1	COORD. CHANGES	03/21/2023
---	----------------	------------

SHEET TITLE
MECHANICAL SECOND LEVEL FLOOR PLAN

SHEET NUMBER
M-202

1 MECHANICAL SECOND FLOOR PLAN
 1/4"=1'-0"

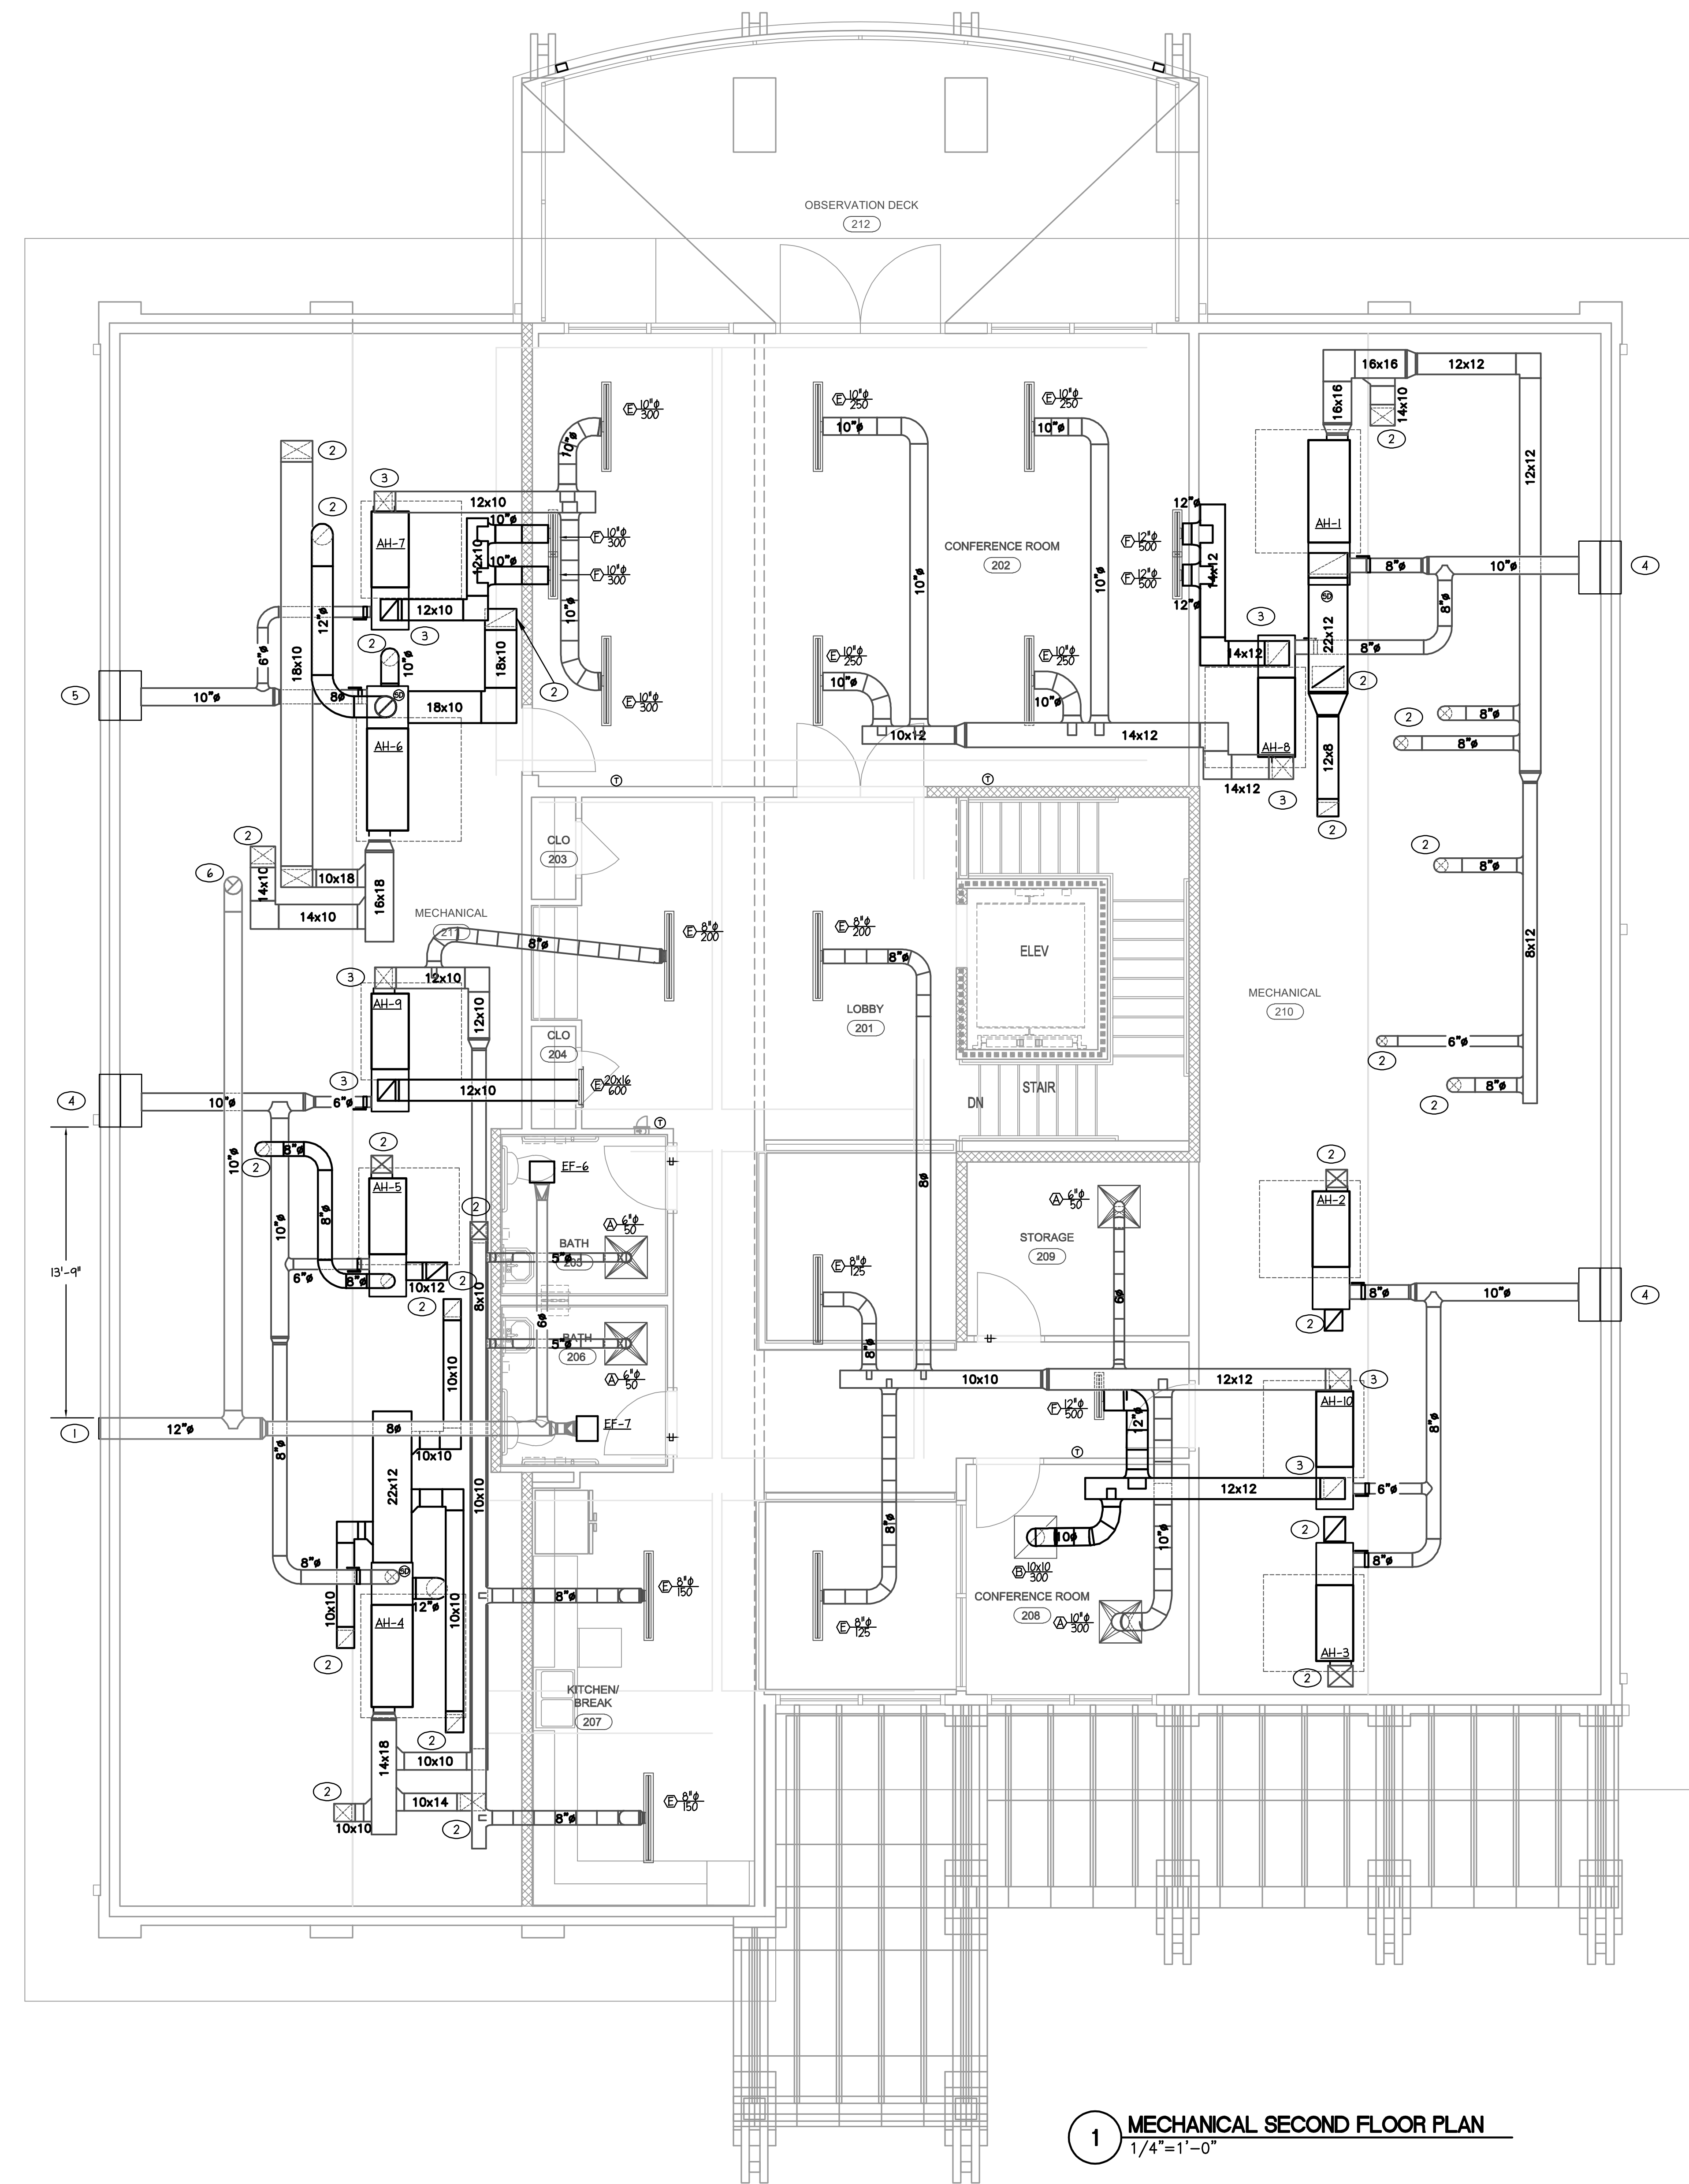
NOTE:
 RENOVATED SUPPLY AND RETURN DUCTWORK ROUTING FOR AH-1, AH-2, AH-3, AH-4, AH-5, AND AH-6 TO FIT BETWEEN NEW TRUSS DESIGN.
